**DISCHARGE PLAN APPLICATION AND
APPLICATION FOR AUTHORIZATION TO INJECT,
PER OIL CONSERVATION DIVISION FORM C-108,
INTO CLASS I WELL WDW-1 AND
PROPOSED WDW-2 AND WDW-3**

RE: Navajo Refining Company WDW-2 Discharge Plan Application
Response to New Mexico Oil Conservation Division Comments Received August 6,
1999, and August 10, 1999
Subsurface Project No. 60A4937

**RESPONSE TO COMMENTS ON THE
DISCHARGE PLAN APPLICATION
RECEIVED ON AUGUST 6 AND 10, 1999 FROM THE
NEW MEXICO OIL CONSERVATION DIVISION**

FIGURE 1

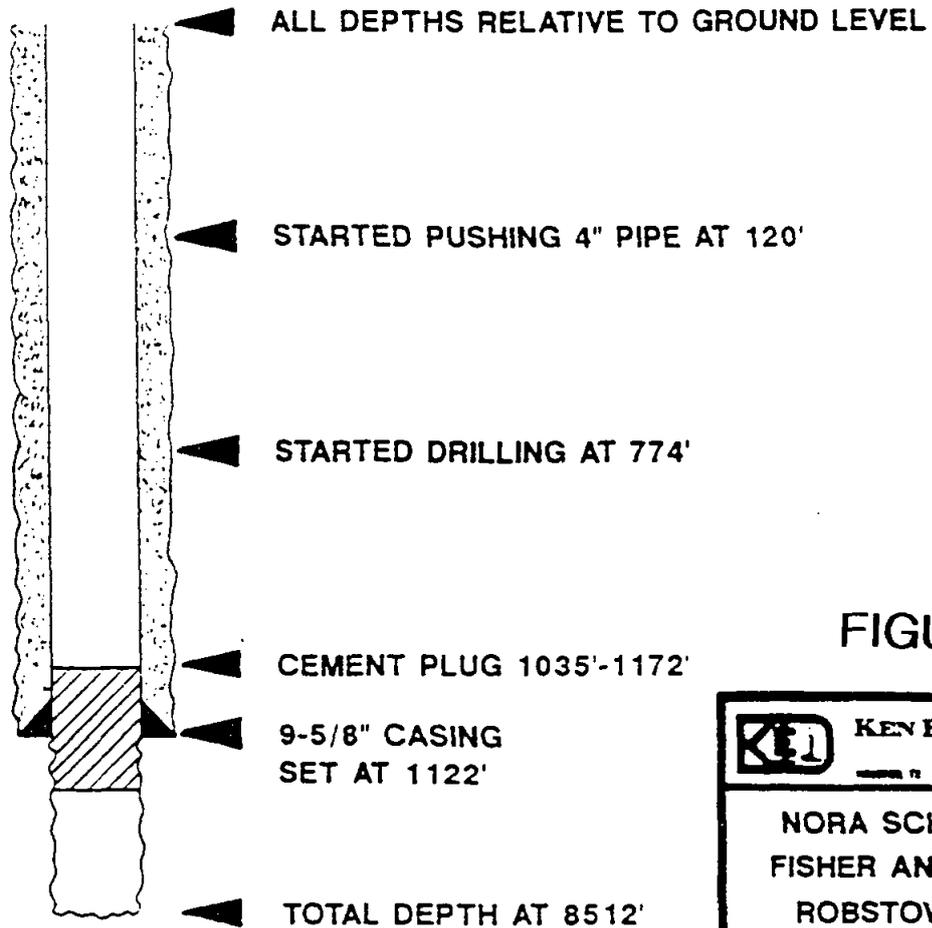
- 4. OCD questioned whether Artificial Penetration No. 851 is adequately plugged to prevent vertical fluid migration from the injection zone into shallower, salt-water bearing zones. (This comment was relayed to Navajo in a conversation with Mr. Wayne Price of the OCD on August 10, 1999).**

Mud density, in general, should not change measurably over the long term because mud has gel strength, as discussed in the next section. Figures 1 and 2 and Table I provide information on a 29-year-old mud sample obtained from the annulus of a plugged and abandoned well in South Texas. As the data indicate, the mud density remained fairly constant throughout the column over the 29-year static period, as expected from the basic chemical and physical properties of drilling mud. If solids settling were a major driving force in a mud column, the mud density at the top would be expected to be less than the average column mud weight. It is of some interest to note that the highest-density sample, approximately 12.5 lb/gal, was obtained from the top of the mud column and not from the bottom, as would be expected for significant settling of solids.

A review of the data presented in Table I and Figures 1 and 2 shows that settling is not a likely problem for drilling mud. Since mud density is not likely to change significantly over long periods of time, it is clear that, if the original mud had sufficient density to prevent fluid migration between zones, then the mud, based on density effects alone, will provide a positive seal against fluid migration until the pressure in the injection interval exceeds the resistance provided by the mud density, mud gel strength, and other formation-related factors.
